RBG-46495

Subject: River Bend Station
Docket Nos. 50-458 and 72-49
License No. NPF-47
Supplement to Revised License Amendment Request (LAR) 2004-26, "Use of the Fuel Building Cask Handling Crane for Dry Spent Fuel Cask Loading Operations"

Response to Additional RAIs for LAR 2004-26

**Response to Spent Fuel Project Office Comments
as Discussed in Teleconference of October 7, 2005
and Teleconference of November 14, 2005**

MPC lid-to-shell weld model

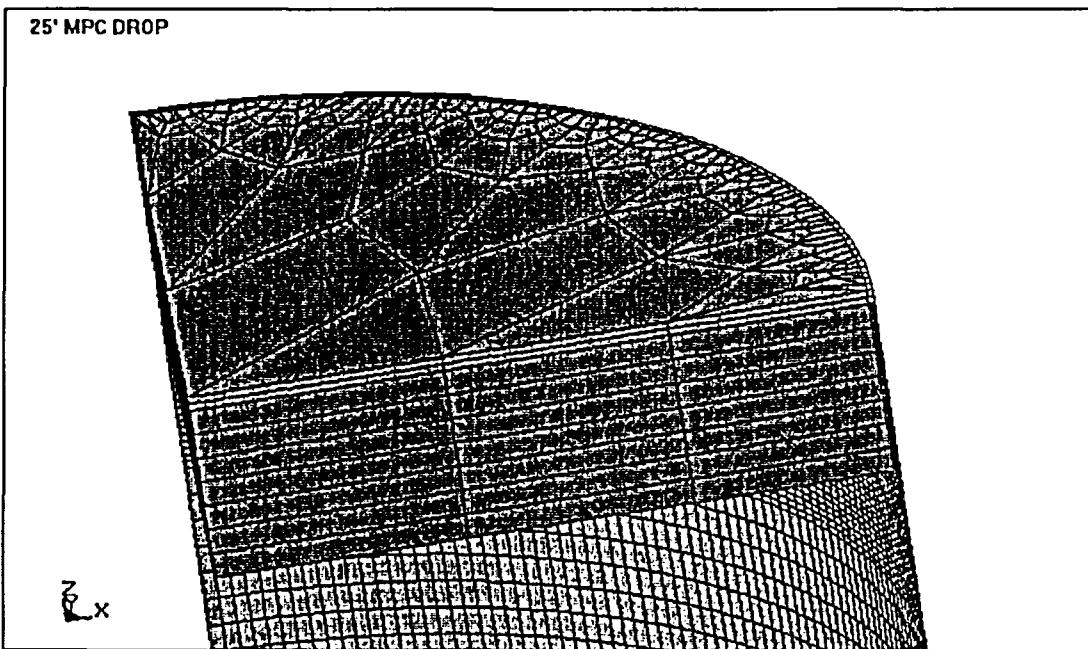
Correction to response to question 2.1

In the HI-TRAC drop analysis, the MPC lid-to-shell weld joint was modeled by using the LS-DYNA command “*CONSTRAINED_SPOTWELD” at 26 locations around the circumferential weld line of the quarter MPC model with full consideration of the 1/16” gap between the lid and the shell body (a constrained spot weld every 2”). Since the ½” thick MPC shell was modeled with shell elements, each pair of constrained shell/lid nodes that represent the local weld connection are distanced at 0.3125” radially, which is the sum of the lid-to-shell radial gap (1/16”) and one half of the shell thickness (1/4”). The following figure shows the weld connection of the LS-DYNA MPC model. The figure shows the top view of the MPC lid (modeled using solid elements), and an end view of the shell (modeled using thin shell elements). It should be pointed out that the HI-STORM FSAR has demonstrated that the MPC lid-to-shell weld joint will not fail as long as the design basis deceleration is not exceeded, which is true for the analyzed 3.5” drop event.
